TDIS alignment findings and next actions

2020/08/31 ([Indico link](#))

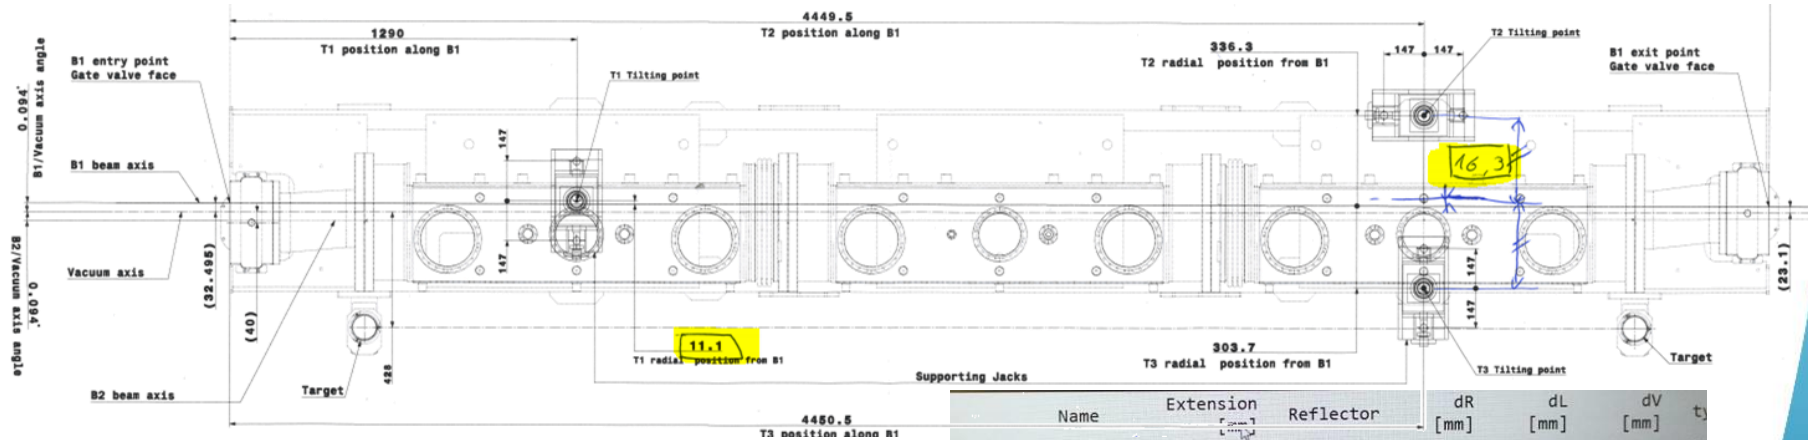
- TDIS P2 – alignment non-conformities (NCR: [EDMS 2407349](#))
- Jacks' end-stops were reached (towards passage side) but the TDIS was between 10mm (upstream side) and 15mm (downstream) away from the its target position

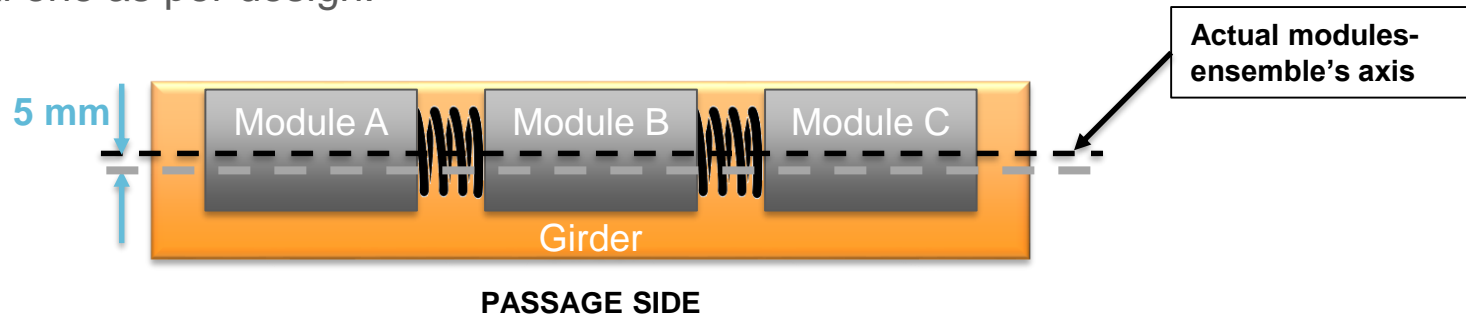
- TDIS P2 – alignment non-conformities (NCR: [EDMS 2407349](#))
- Data analysis revealed the 3 modules were not correctly aligned with respect to the girder. At present there is a **5mm-offset** between the 3-modules-ensemble's axis and its theoretical one as per design:

- However, even if the modules were correctly positioned it would not suffice to reach the required position => **Another issue must underlie** (jacks misalignment? incorrect references taken for alignment? actual Integration geometry not matching design?)

Screenshot provided by Luca Gentini

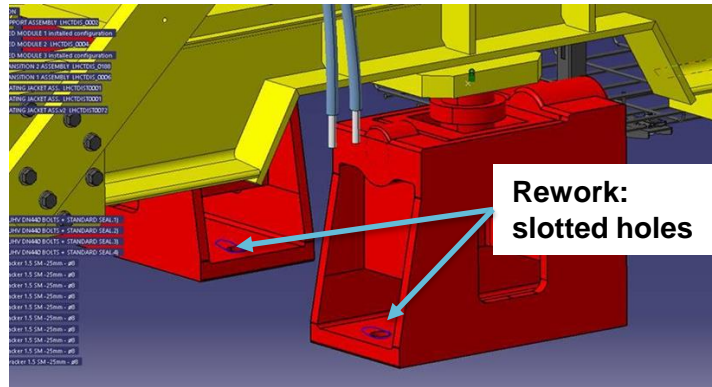
- TDIS P2 – alignment non-conformities (NCR: [EDMS 2407349](#))
- Were the jacks not properly positioned, EN/STI-TCD would propose to rework them in order to allow its radial displacement towards the passage side:

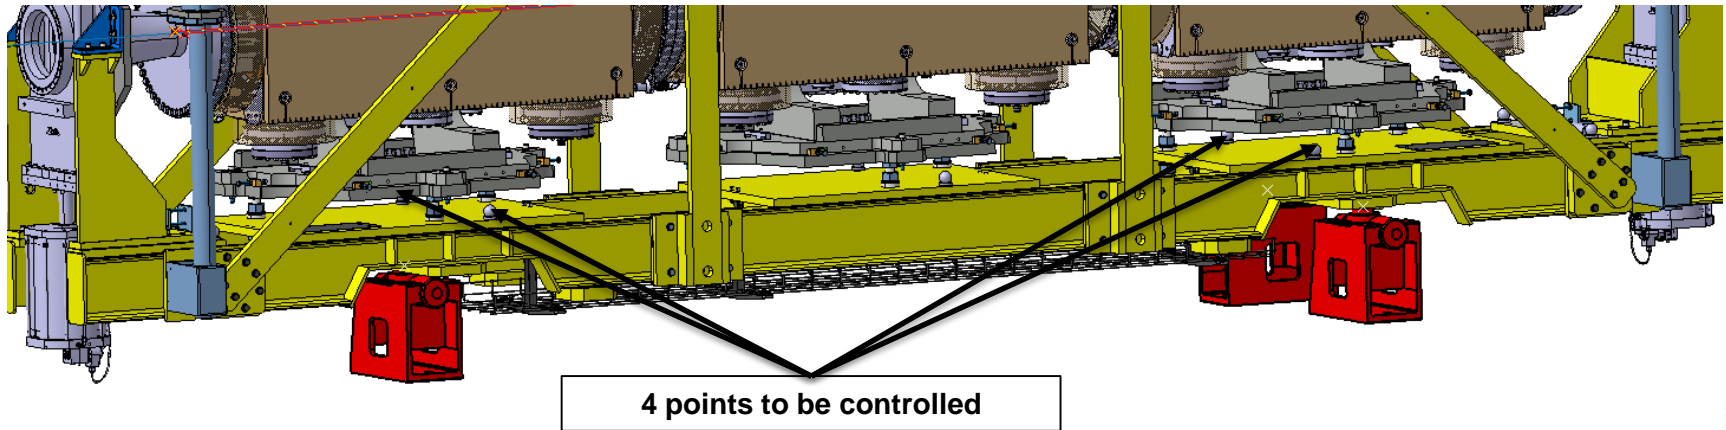
- TDIS P8 – update about on-surface alignment / tunnel set-up
 - TDIS tanks linked by means of bellows => assembly stiff to torsion. When one module is displaced relatively to the girder the other two modules are also displaced and elastically deform the girder.
 - To avoid the issue the girder's reinforcement structure has been installed prior to the alignment phase (instead of after, as it was done for TDIS P2). That minimises girder torsion during modules displacement.

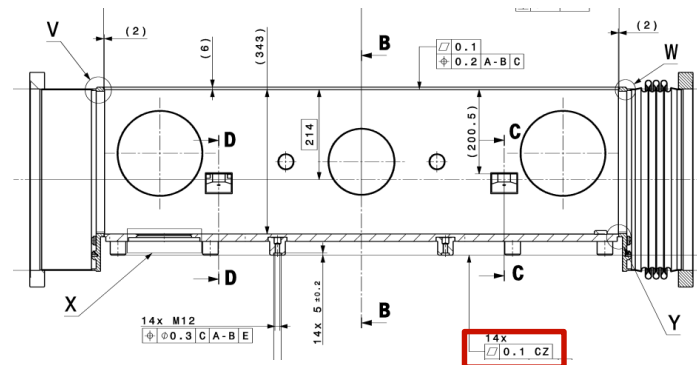
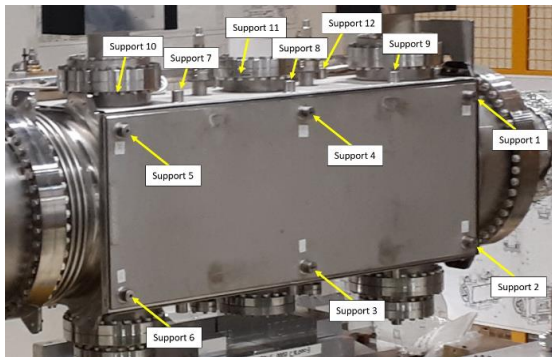
- TDIS alignment reports' content
 - EN/STI-TCD expects from EN/SMM-ASG a report for each TDIS unit containing:
 2. Data of each module's coordinate system :

*It must be verified that the 0.1mm-flatness spec is met

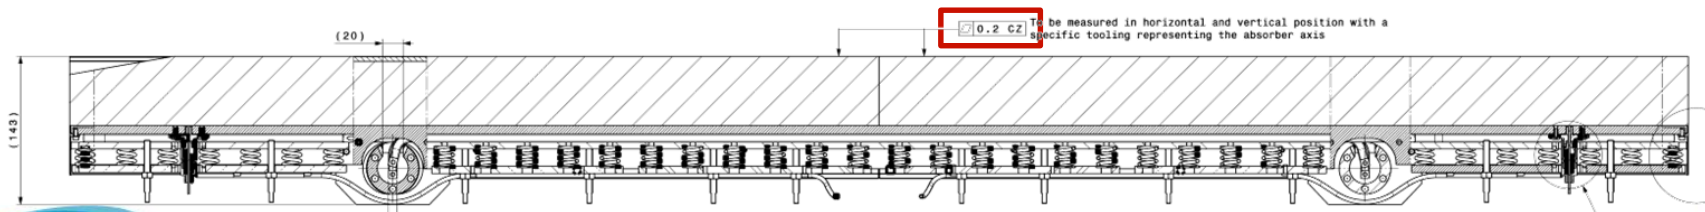
- TDIS alignment reports' content
- EN/STI-TCD expects from EN/SMM-ASG a report for each TDIS unit containing:
 3. Data of each jaw:

*It must be verified that the 0.2mm-flatness spec is met
